PCN Number:	20260713000.1	PCN Issued	July 22, 2026
Qualification of RFAB site and Die revision for select devices		Sample request deadline:	September 20, 2026
		Estimated 1st ship date:	October 20, 2026
Sample requests received after September 20, 2026 will not be supported.

Texas Instruments is pleased to announce the addition of RFAB using the LBC9PLV qualified process technology, die revision, and datasheet update for the devices listed below.

TL1963A, TL1963A-15, TL1963A-18, TL1963A-25, TL1963A-33

Sample product shipping label (not actual product label):

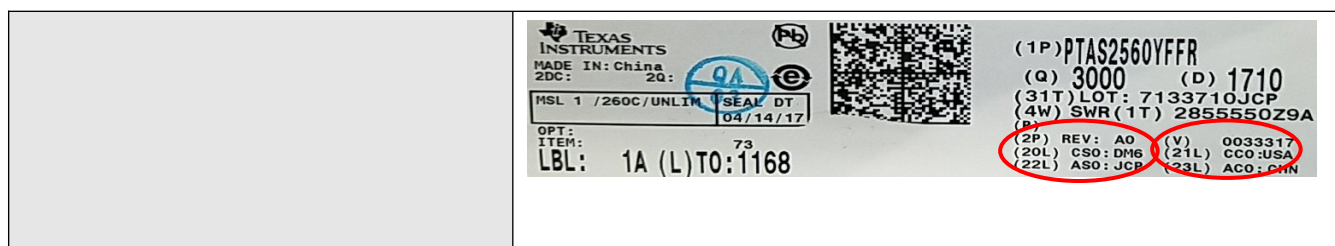
Changes to product identification resulting from this PCN:
